City of Sumter Design Review Board

April 23, 2026

HP-26-03 15 Church St (City)

Figure 3 - Proposed Replacement Door Alternative Styles Submitted by Applicant

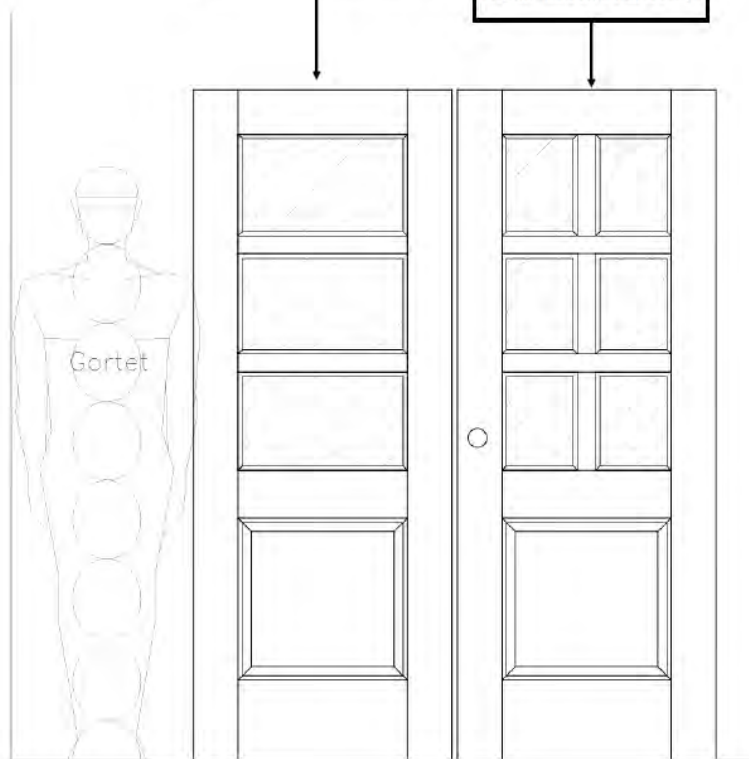
The applicant is proposing to change existing hollow core entry door with single strength window glass to solid core with insulated windows to provide additional facility security, given the unique challenges faced by the Temple in this regard. The applicant has supplied two design alternatives, one with a central muntin on the glass (6 window panel configuration), and one without the muntin (3 window panel configuration) that more closely matches the existing horizontal window configuration.

Of the two alternatives, staff recommends approval of the 3 window panel alternative, as it more closely matches the style of the existing door and reflects the midcentury architectural style of the building on which it is to be installed.
